Philco Radio & Television Corp.

Model: 50-922	Chassis:	Year: Pre 1951
	Power:	Circuit:	IF:
	Tubes:		
	Bands:

PHILCO RADIO MODELS 50-920, 50-921 AND 50-922

MODELS 50-920,
50-921, 50-922

Figure 3. Symbolized Chassis, Showing Parts Placement

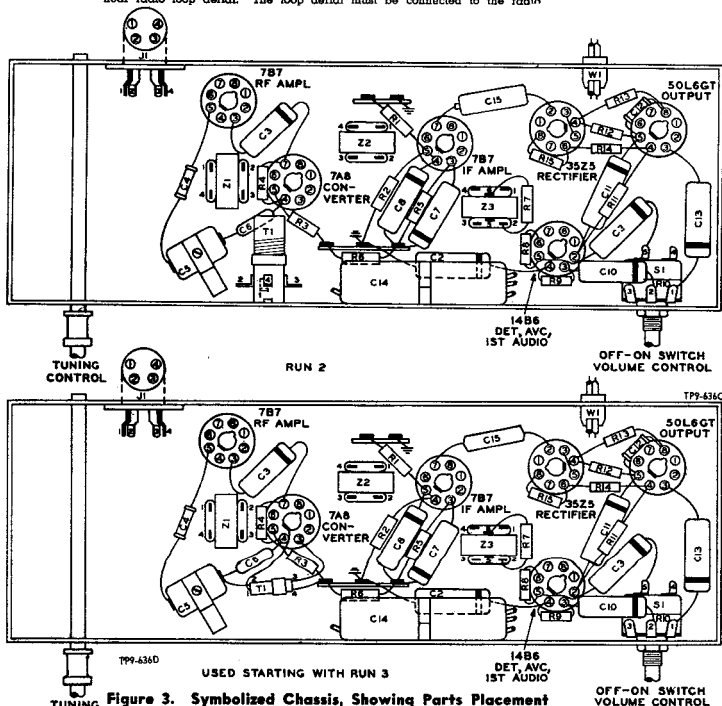
Run 2: I.F. changed from 265 kc. to 455 kc.

Run 3: Oscillator coil, T1, changed from Part No. 32-4190-6 to Part No. 32-4263-3. This change was

to save space only; the latter, Part No. 32-4263-3, should be ordered in either case.

Run 4: Condenser C4 changed in value from 20 μ f. Part No. 30-1224-56, to 13 μ f., Part No. 30-1224-68, to insure proper padding at 1620 kc.
